**BROOKLYN 1B**  
1309 NE 66TH ST

DESIGN REVIEW RECOMMENDATION  
25 JUNE 2018  
DPD #3026788

ADDRESS: 1309 NE 66TH ST  
PROJECT #: 3026788

17.0 DEPARTURE #2

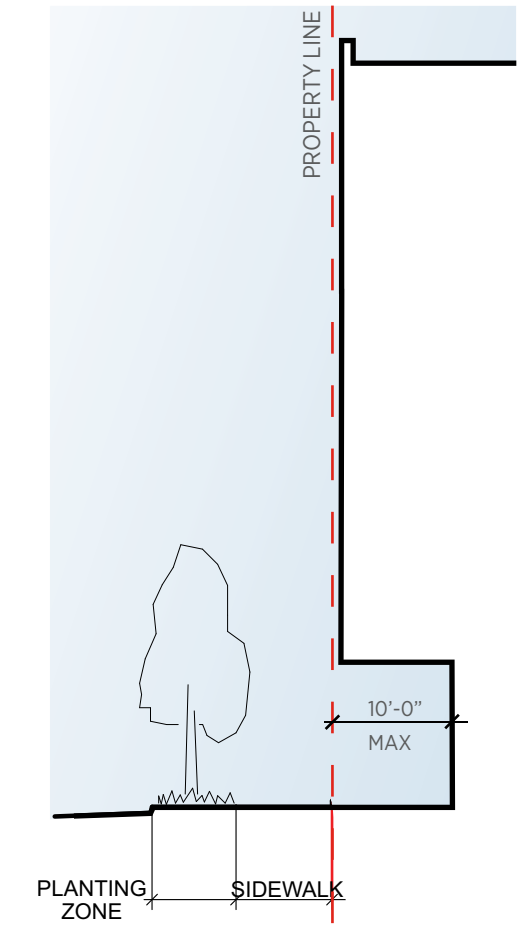
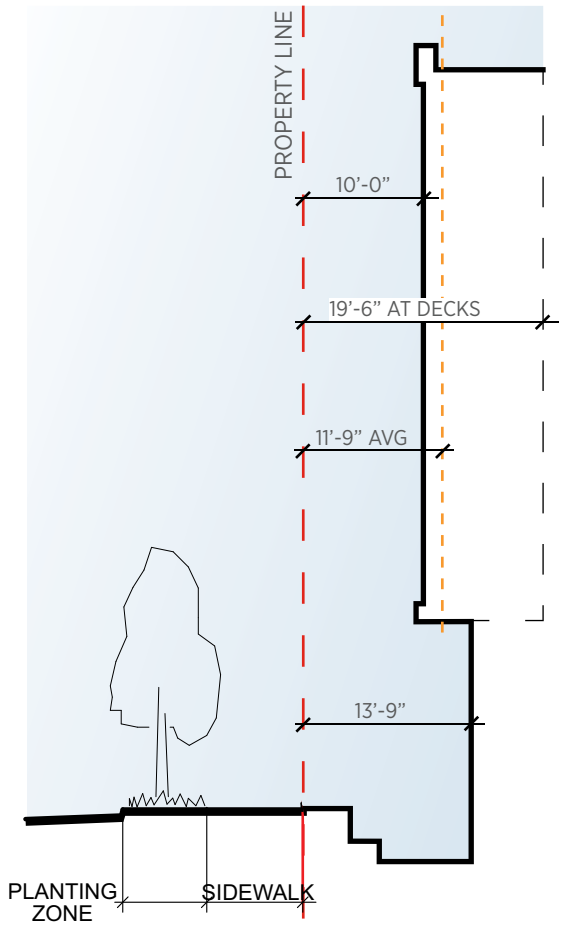
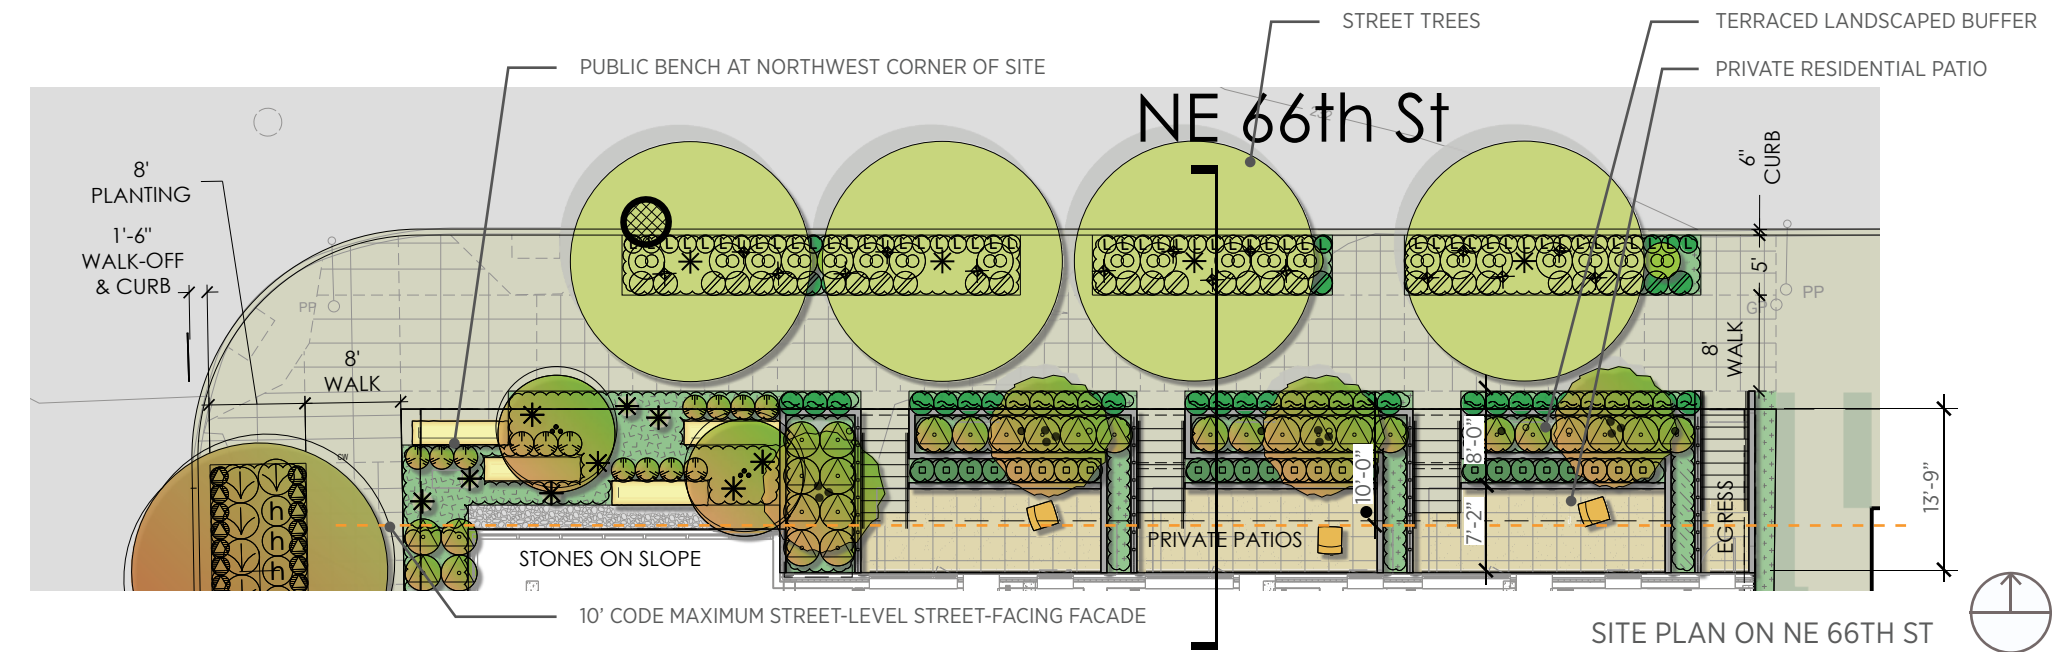
The Board indicated preliminary support for this departure request provided the street level experience is truly enhanced by the highlighted pedestrian amenities and high quality landscape design.

Departure from the maximum 10’ distance to the street lot line and instead provide a 13’-9” distance to the street lot line which will include a landscape/open space buffer.

The departure would allow for more ability to enhance the pedestrian environment along NE 66th St by providing additional space for improvements, including space for street trees, pedestrian seating, and residential unit yards. Without an additional 3’-9” setback, the topography of the site would greatly limit potential street activation provided by these patios and would allow less light into the ground level units. Either the depth of the residential patios and/or the landscaping buffer would be reduced therefore diminishing the quality of the patios and planting.

17.0 DEPARTURE #3

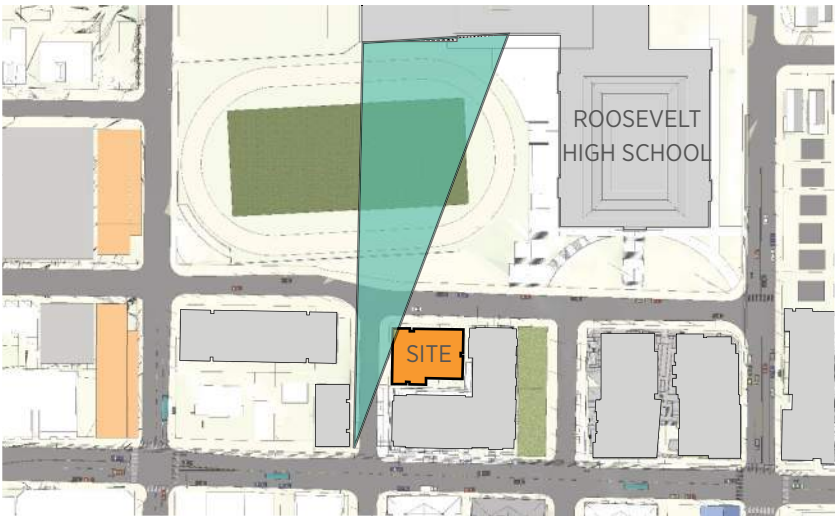
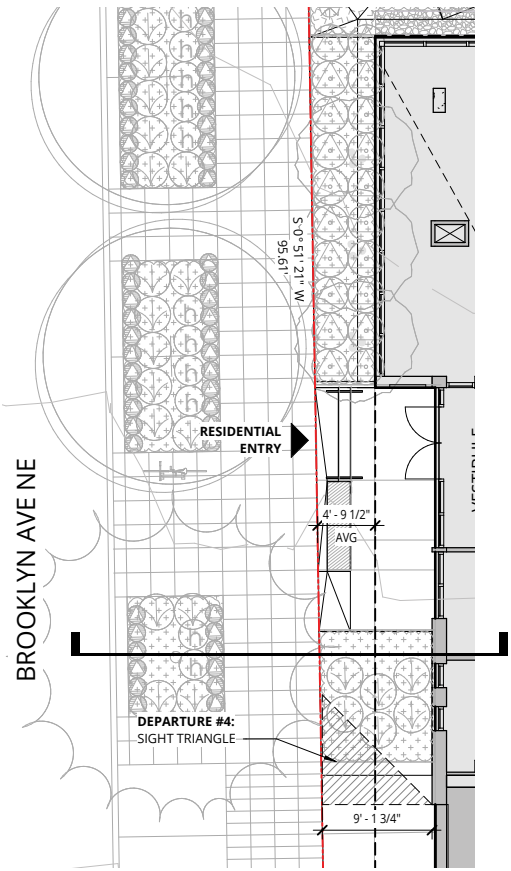
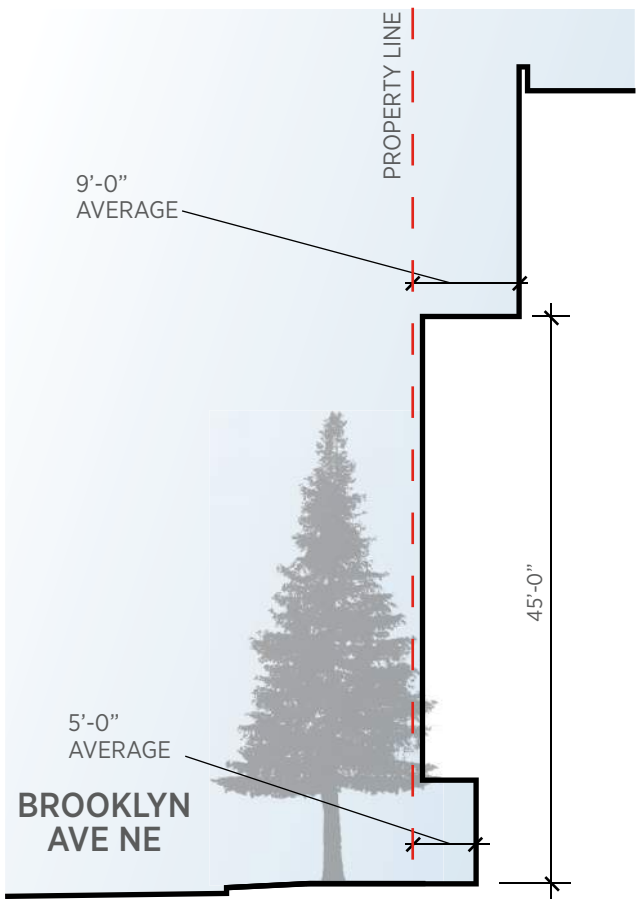
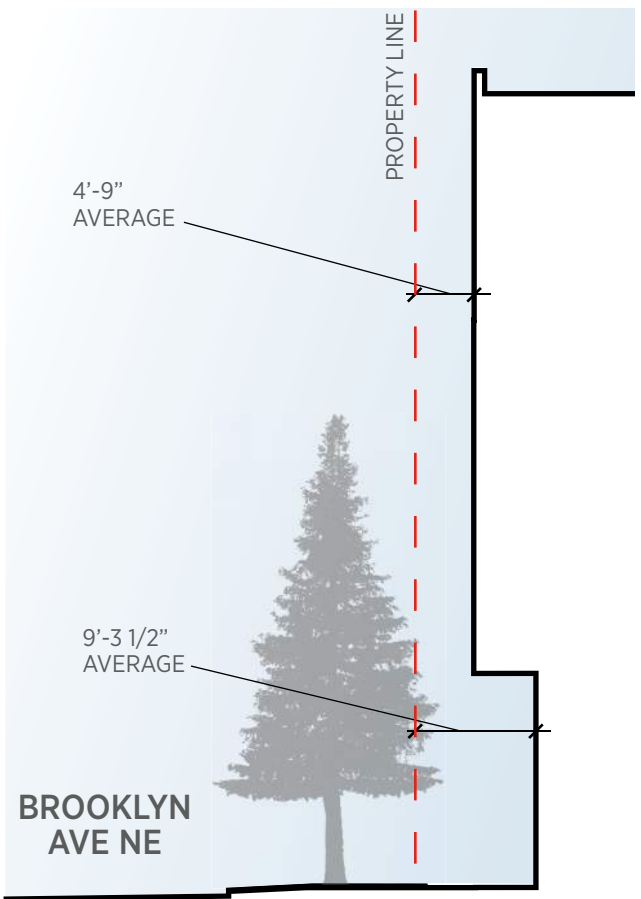
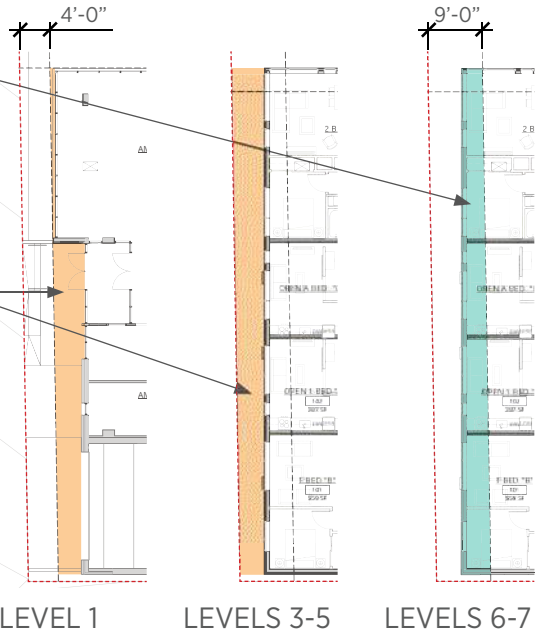
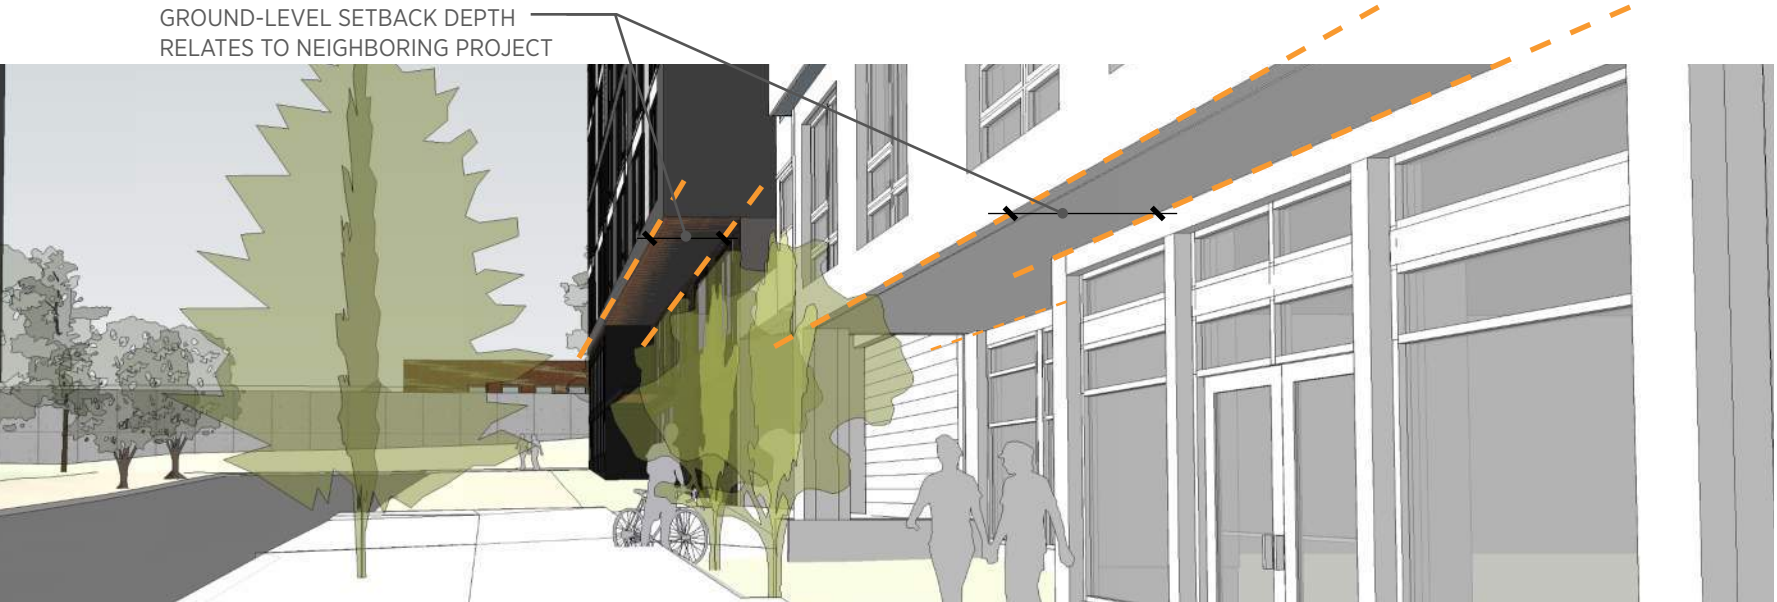
The Board indicated preliminary support for this departure request provided the street level experience is truly enhanced by the highlighted pedestrian amenities and high quality landscape design.

Departure from the additional 4-foot upper level setback and instead provide an additional setback at the street level and second level. The proposed upper level is setback an average of 4'-9" from the property line and the proposed ground-level is setback is 9'-3" from the property line.

The departure would allow for more ability to enhance the pedestrian environment along Brooklyn by providing additional space for improvements, including space for street trees and pedestrian seating as well as additional area for garage access site triangle. The code required upper-level setback does not provide views of the school from the street level as recommended in the Roosevelt Neighborhood Design Guidelines. The departure will better allow the proposed building to relate to neighboring proposed and under-construction projects.

17.0 DEPARTURE #4

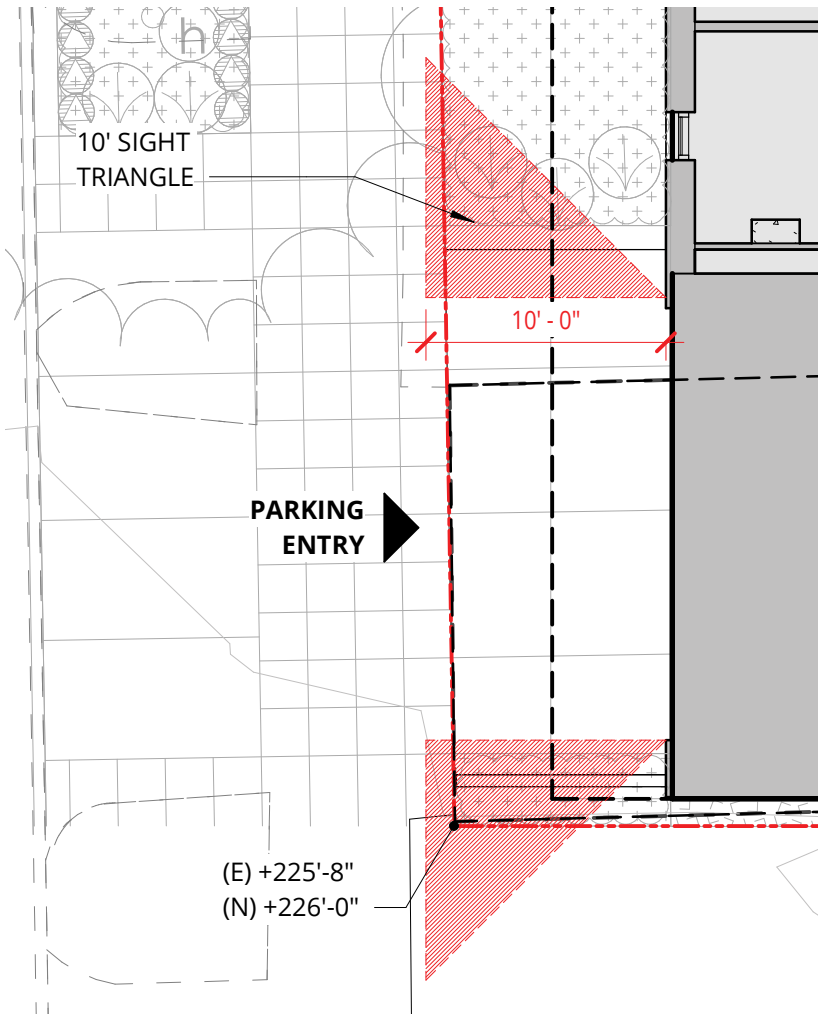
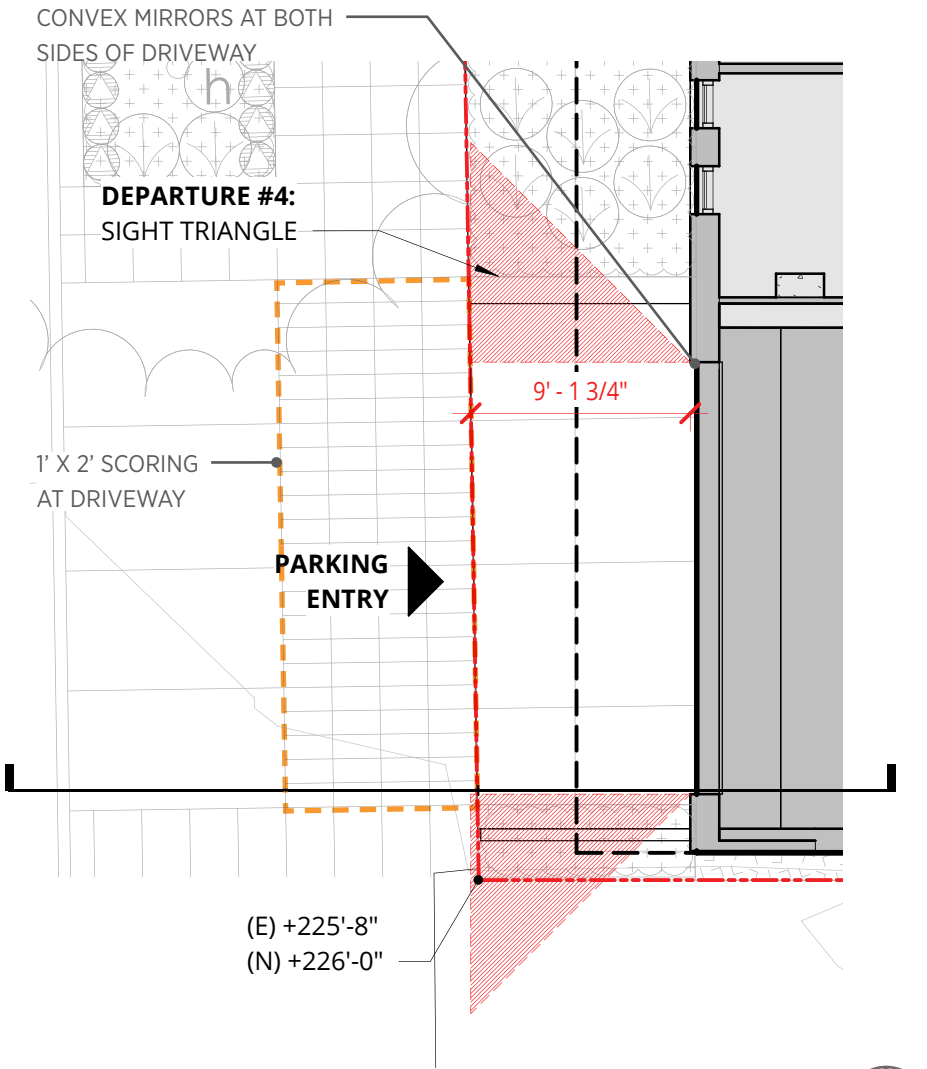
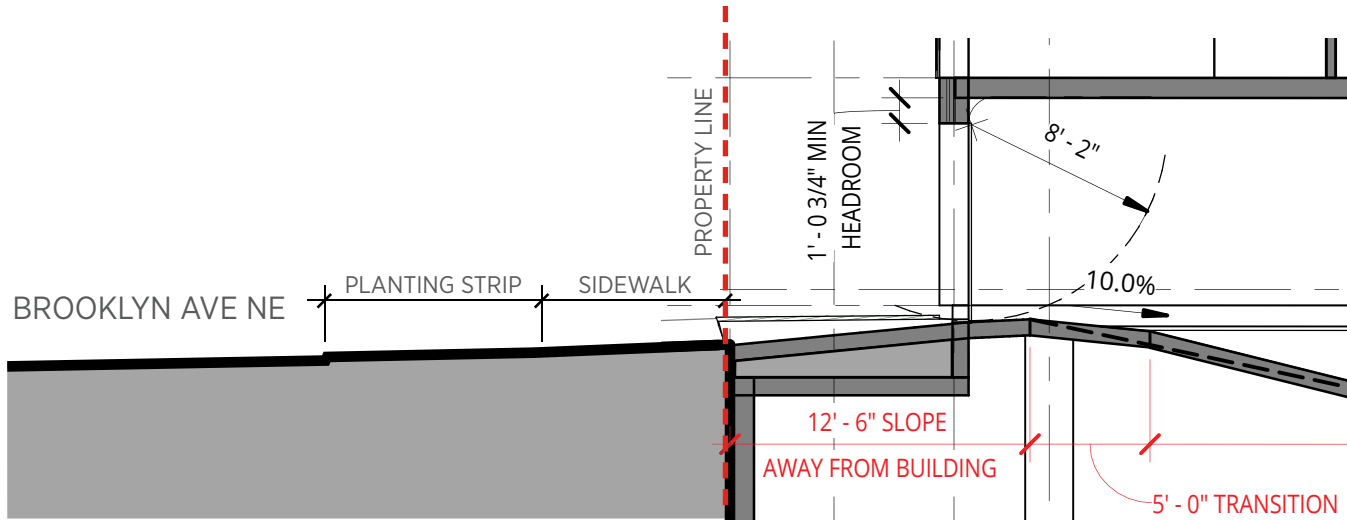
The Board indicated preliminary support for this departure request but wanted to see clear documentation as to how and/or why the reduced site triangle works and how the reduced site triangle is safe.

Departure for a reduction in the required 10 feet unobstructed distance of 10 feet down to 9'-1 3/4".

Use of mirrors and textured pavement in lieu of providing the full sight triangle to diminish presence of garage entry at the street. Brooklyn Ave NE is a side street that experiences an increase in pedestrian traffic during school hours. The reduction in the site triangle depth, as well as using alternative measures will help to minimize any potential impacts to pedestrian traffic, along the street as well as helping to maintain a consistent street frontage. Along with departure 5, a reduced sight triangle allows less area be dedicated to vehicular garage access and increases pedestrian safety by allowing a safer, flat vehicular approach between the sidewalk and the building edge.
